# ATTACHMENT A

## Application Package

Explanation of Request: BUILD 8 TOWNHOMES FOR RENT LONG TERM INVESTMENT

**RE: Landscape Comment Responses**  
**8 Unit Townhomes – 2420 Lincoln Street**  
**Hollywood, FL 33020**

**LANDSCAPE PLAN**

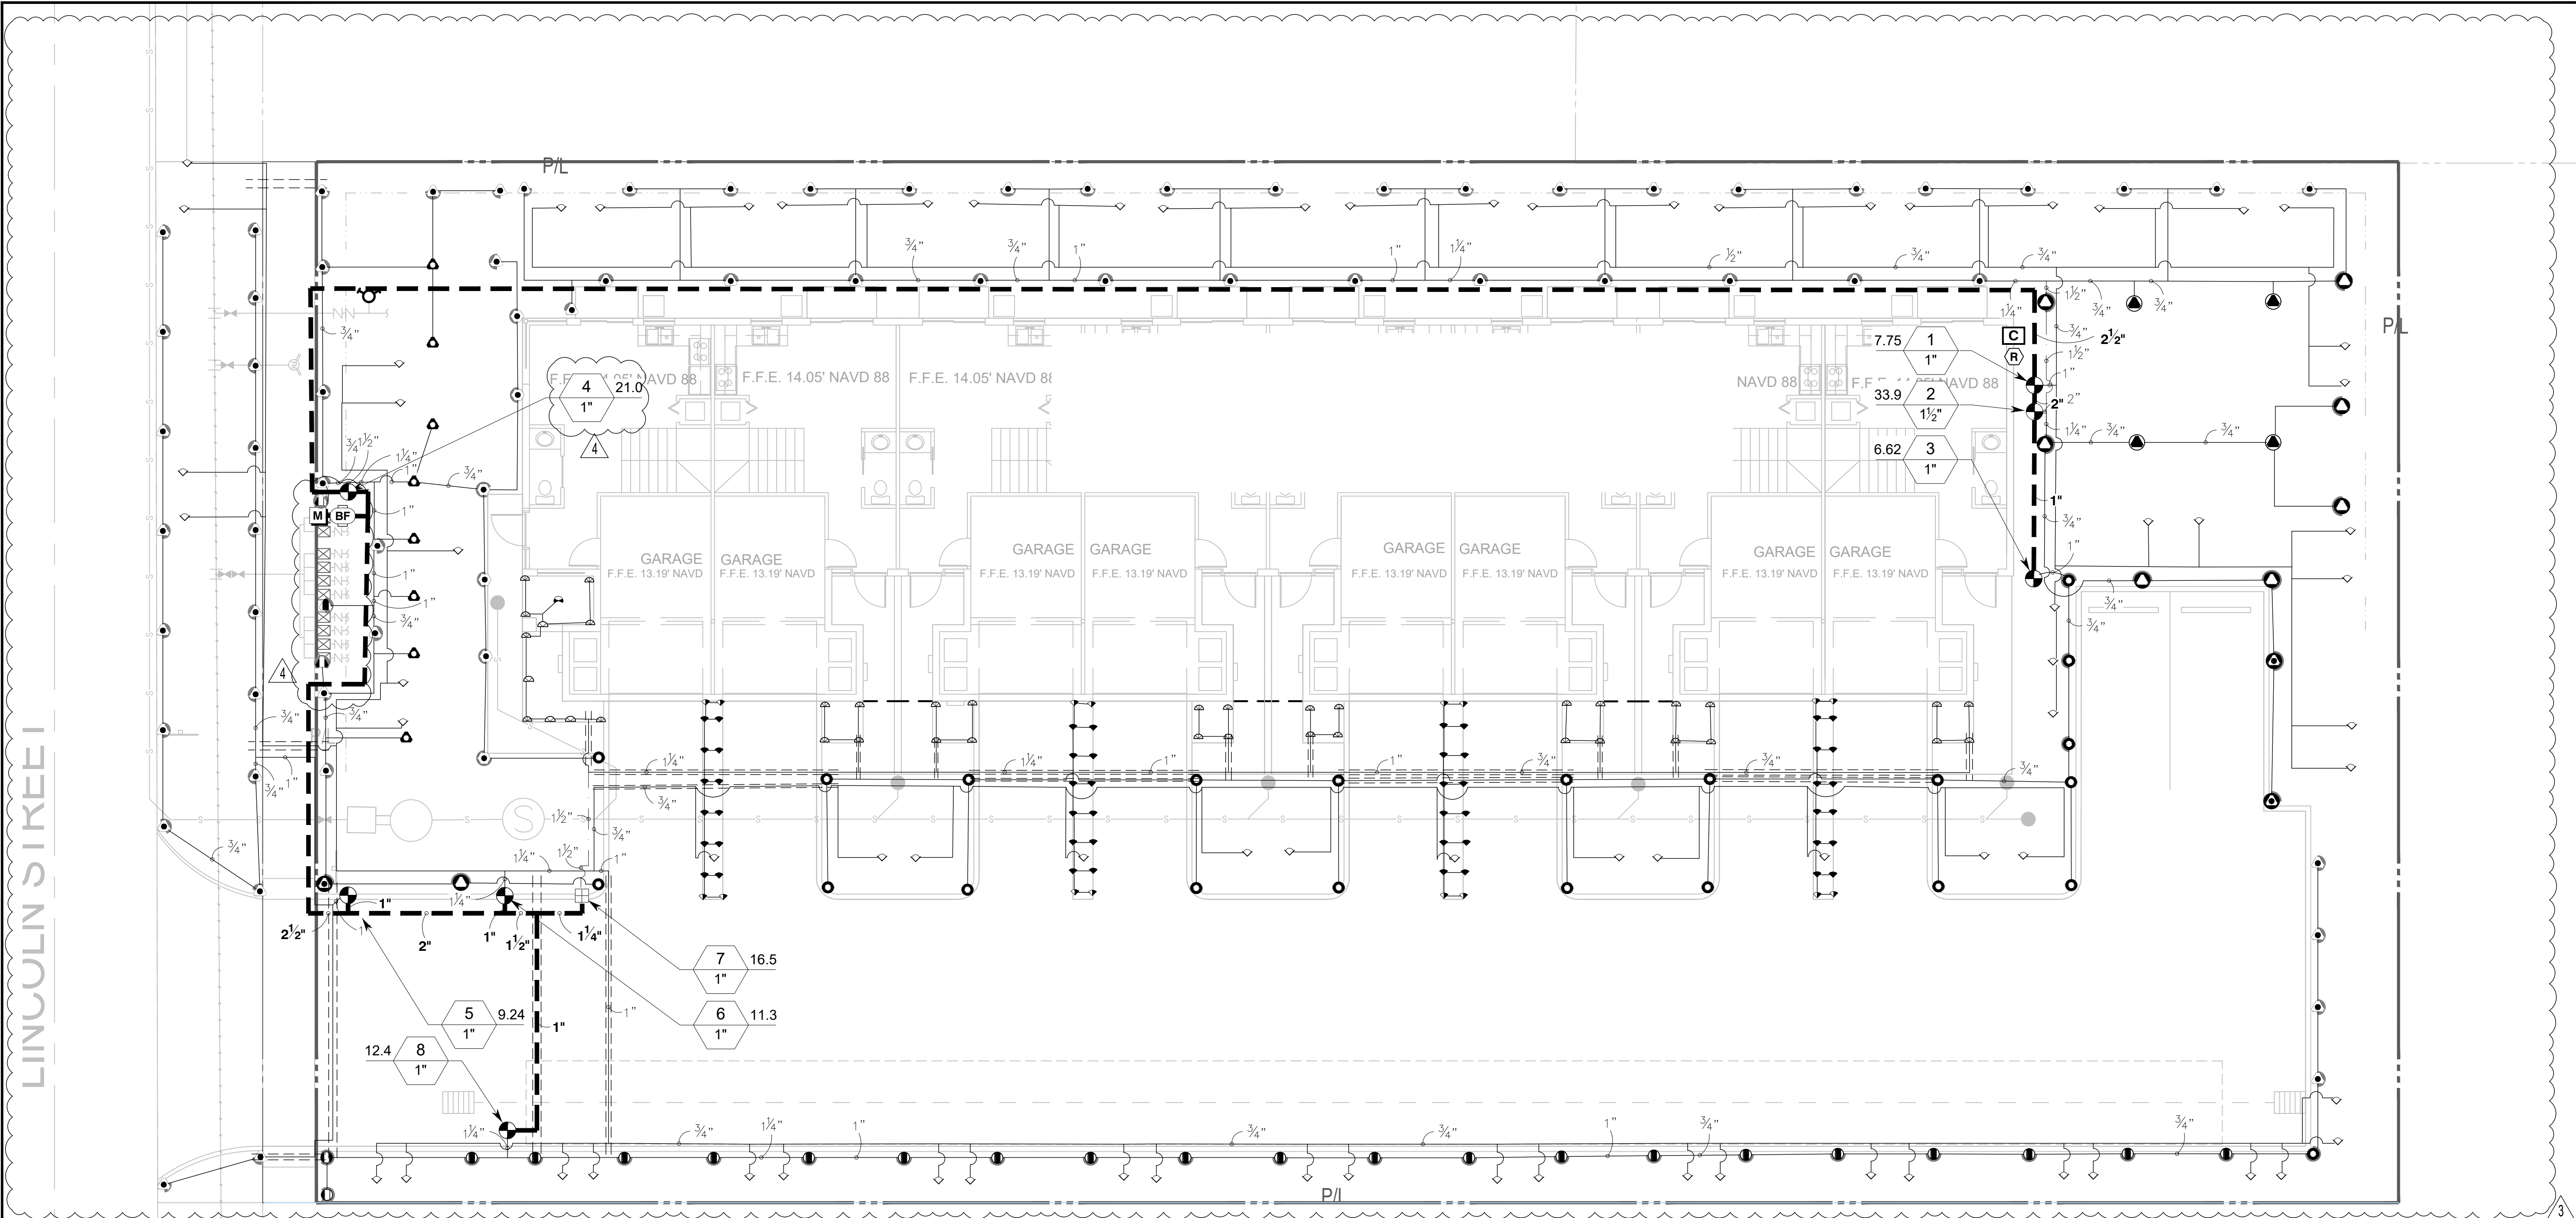
1. Landscape plan is not matching the site plan and civil plans. All plans to match.  
**RESPONSE: Landscape Plans match the site and civil plans. This has been confirmed by the project Civil engineer. See sheet L-2 Landscape Plans SIGNED & DATED 05/09/2025.**

2. Show sewer lines on landscape plan as per civil and connection location into units.  
**RESPONSE: See MEP / Plumbing plans for sewer line connection location into units. Landscape Plans match the site and civil plans. This has been confirmed by the project Civil engineer. See sheet L-2 Landscape Plans SIGNED & DATED 05/09/2025.**

3. Above ground equipment: Where required for screening purposes, hedge shall be planted at equipment height for visual screening. Provide minimum of 36" ht. Provide hedge for AC and backflow preventor as needed. Native hedge is recommended.

4. Add note: ALL ABOVE GROUND EQUIPMENT SHALL BE SCREENED WITH HEDGE AT EQUIPMENT HEIGHT.  
**RESPONSE: See note on sheet L-2 Landscape Plan, lower left-hand corner. Also see response to Comment #3.**

5. For proposed street trees, provide root barrier 5' in each direction of the trunk along the sidewalk and also the roadway. Review location of proposed tree and water meters.

7. Provide different tree symbol and reduce lineweight as needed to read the landscape clearly, specifically behind the sidewalk.

8. Marble chips may be used as accent in planting areas but not in lieu of large planting areas. As per code, all landscape areas shall be covered with living plant material. Provide sod and label on plan as needed.

**RESPONSE: Screening hedges have been increased to 36" ht. Hedges are provided at all AC and backflow preventer locations. *Psychotria nervosa* (Code: PSY, native), & *Cordyline fruticosa* 'Black Magic' ( Code: CBM, non-native), and *Strelitzia reginae* (Code: SRG, non-native) are used for equipment screening & specified at minimum 36" height. These are all Florida Friendly plant materials. See sheet L-2 Landscape Plan and Plant Schedule SIGNED & DATED 05/09/2025.**

**RESPONSE: 10 ft length Root barriers are now shown along the asphalt roadway and sidewalk for proposed Street Trees (CO-S). A 10 ft dimension has been added to the Landscape Plan to demonstrate root barriers comply with the 10 ft length requested. Street Trees are shown with adequate distance from water meters – there is currently *NO CONFLICT*. See sheet L-2 Landscape Plans SIGNED & DATED 05/09/2025.**

**RESPONSE:** Different symbols are now used for the proposed Satin leaf trees. Also, shrub and groundcover area hatches are provided in a lighter shade of gray for legibility. See sheet L-2 Landscape Plan SIGNED & DATED 05/09/2025.

**RESPONSE:** Marble chips are no longer shown on the landscape plan and have been replaced with a SOD label at the meter bank locations. See sheet L-2 Landscape Plan.
